STAFF REPORT ACTION REQUIRED

Fence Exemption Request – 93 Raymore Drive

Date:	May 2, 2008
To:	Etobicoke York Community Council
From:	Curtis Sealock, Manager, Municipal Licensing and Standards
Wards:	Ward 2 - Etobicoke North
Reference Number:	ML&S Folder Number 08-146369 FEN

Attachment 1 – Site Plan for Proposed Fencing @ 93 Raymore Drive

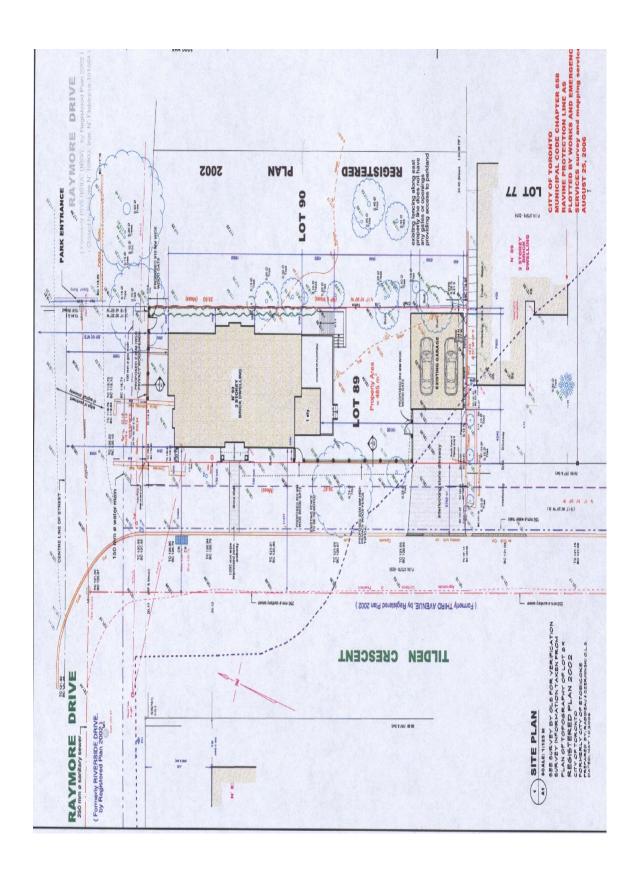
This is a single family detached residential property located at the corner of Raymore Drive and Tilden Crescent in the Scarlett Road and Lawrence Avenue West area of the subject ward, (Attachment 1).

Attachment 2 – Elevation for Proposed Fencing @ 93 Raymore Drive

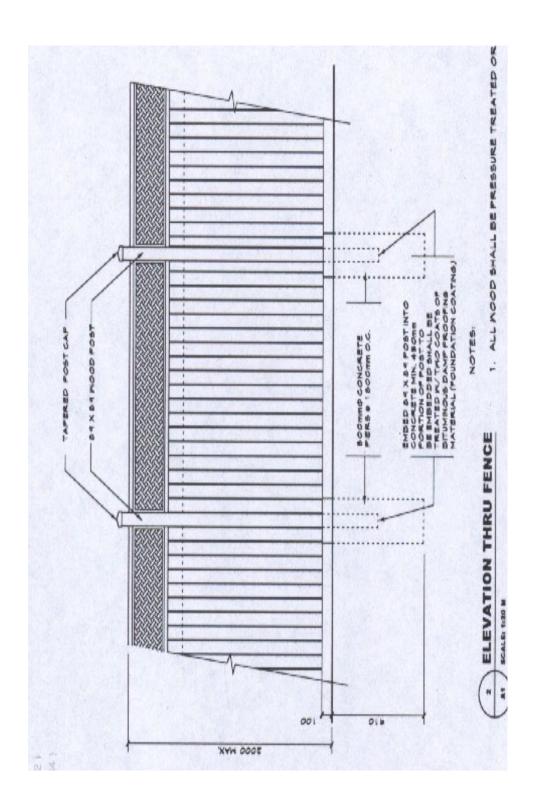
Fences in the front yard within 2.4 metres of the front lot lines are limited to 1.2 metres in height for chain-link fencing or equivalent open construction that does not restrict sight lines and 1.0 metre in height for all other types, pursuant to Section 447-2.B, Chapter 447, Toronto Municipal Code, Fences. The owners are proposing to erect a 2.0 metre high front yard fence that is within 2.4 metres of the front lot line on the subject property, (Attachments 2 and 3).

Fences in the flankage yard within 2.4 metres of a side lot line and 2.4 metres of any driveway are limited to 2.0 metres in height for open mesh chain-link fence or equivalent open fence construction that does not restrict sight lines and 800 millimetres for any other type, pursuant to Section 447-2.B, Chapter 447, Toronto Municipal Code, Fences. The owners are proposing to erect a 2.0 metre high flankage yard fence that is within 2.4 metres of the side lot line and the most southerly portion near the garage is also within 2.4 metres of the driveway on the subject property, (Attachments 2 and 3).

The property owner has requested an exemption to the by-law to enclose the lot for security and privacy reasons. The property owner's proposal also shows that the fence posts and caps will exceed the 2.0 metre height fence panels as proposed. Should the exemption to the by-law requirements be granted, it should be made clear that any approved fence height is to include all components of the fences (panels, lattice-work, posts, decorative caps, etc).

Municipal Licensing and Standards recommend that the Etobicoke York Community Council deny the request for the fence exemption based on noncompliance with the requirements set out in Chapter 447 of the Toronto Municipal Code, Fences.
